Campaign No. 2019080006, September 2019

SUBJECT: **Model S-Class vehicles, (222 platform)
Model Year 2019
Rework torque of A-, B-, and C-pillar trims, as well as wheel arch liners**

Figure 3

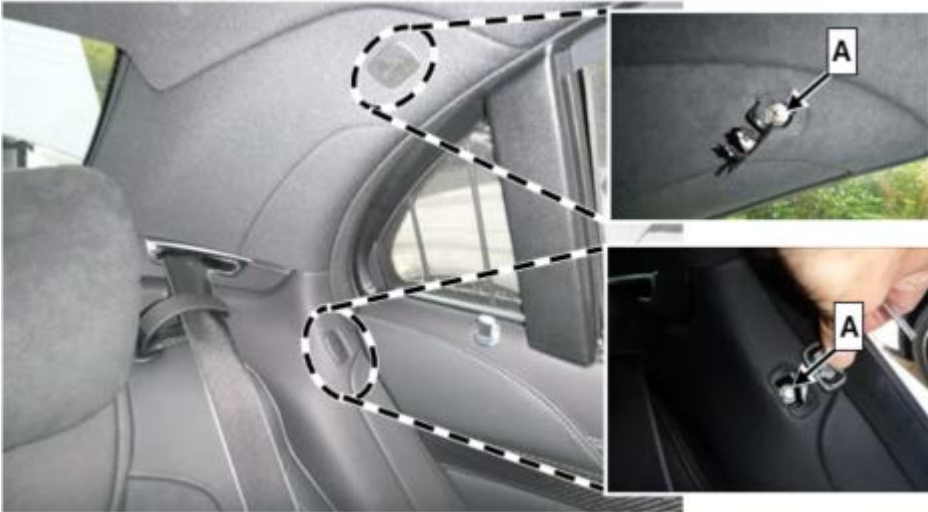
3. Remove SRS cover on C-pillar and wheel arch and correct torque (**Nm** 5) (A, Figure 3).
